KFL1-4 KIT CHANGES AND MANUAL ERRATA

Rev. A-4, January 17, 2011

Figure 1

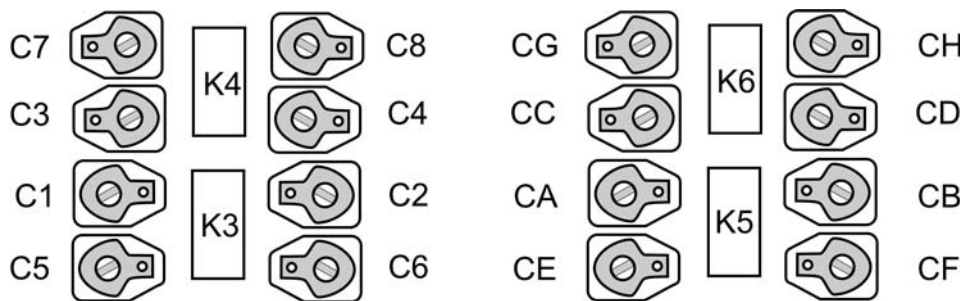
The approximate locations of the 16 trimmer capacitors on the Filter board are shown in Figure 1. Relays K3-K6 are shown for reference. **Note that each trimmer's body has a narrow end, and that they are not all oriented in the same direction.** The trimmers must be oriented as shown to keep their rotor terminals at ground potential. This will allow them to be aligned with a metallic tool.

Install trimmer capacitors C1-C8 and CA-CH with their narrow ends oriented as indicated above (toward the flat side of the outline on the pc board). Each trimmer must be gently pressed down as far as it will go, but be careful not to bend the leads.
